**ADDENDUM NO. 1
TO CONTRACT DOCUMENTS FOR THE
SANTA TERESA WATER TREATMENT PLANT
AIR WASH PIPELINE REPLACEMENT PROJECT
Project No. 93764004 Contract No. C0662**

**ADDENDUM NO. 2
TO CONTRACT DOCUMENTS FOR THE
SANTA TERESA WATER TREATMENT PLANT
AIR WASH PIPELINE REPLACEMENT PROJECT
Project No. 93764004 Contract No. C0662**

ADDENDUM NO. 3
TO CONTRACT DOCUMENTS FOR THE
SANTA TERESA WATER TREATMENT PLANT
AIR WASH PIPELINE REPLACEMENT PROJECT
Project No. 93764004 Contract No. C0662

ATTACHMENT 1: Revised Drawing - G-05

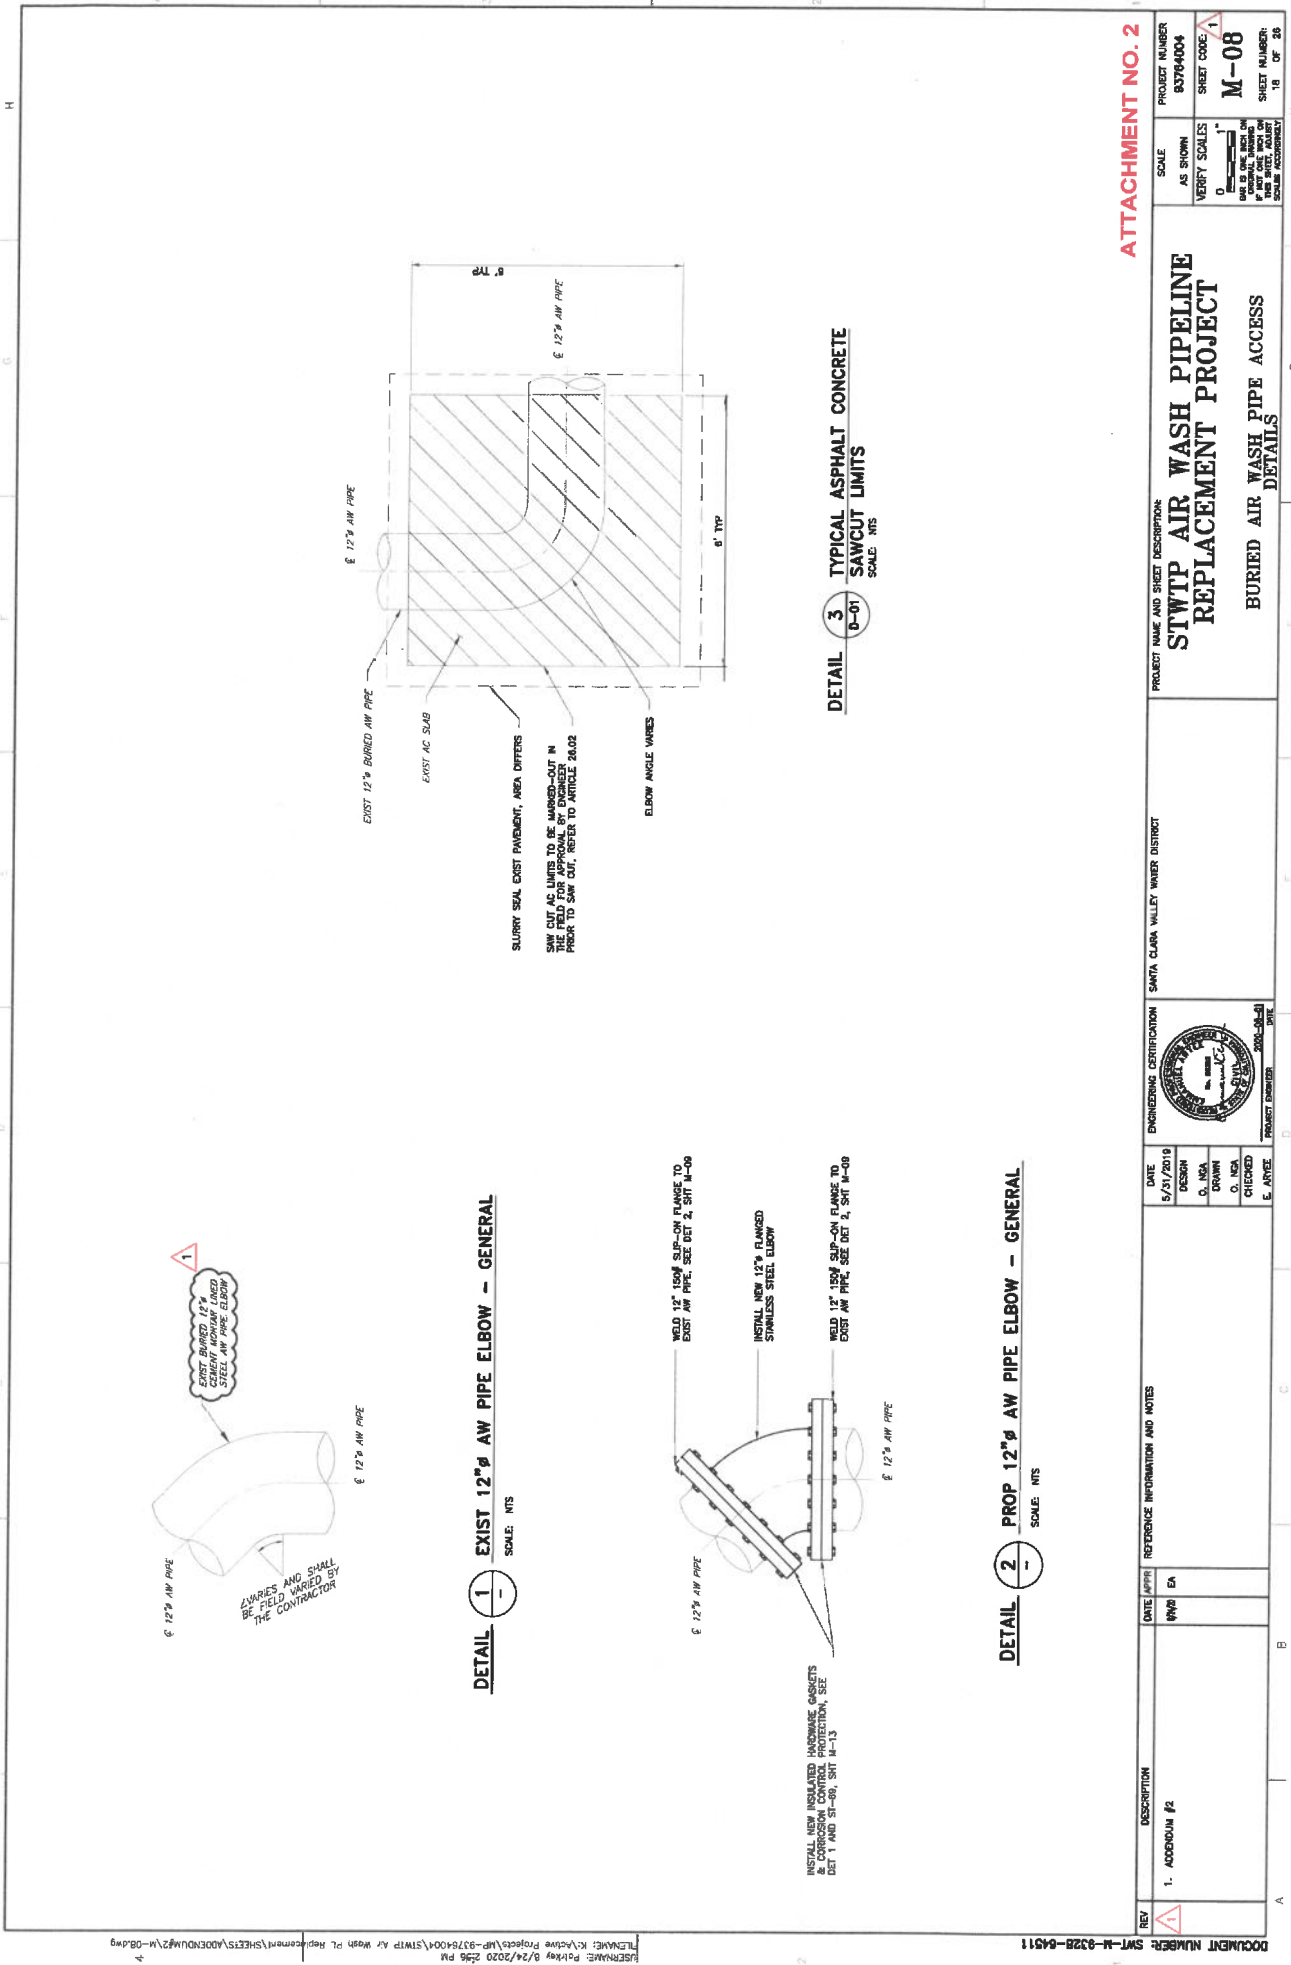
4. REPLACE Sheet G-05, General Site Plan (ATTACHMENT 1)
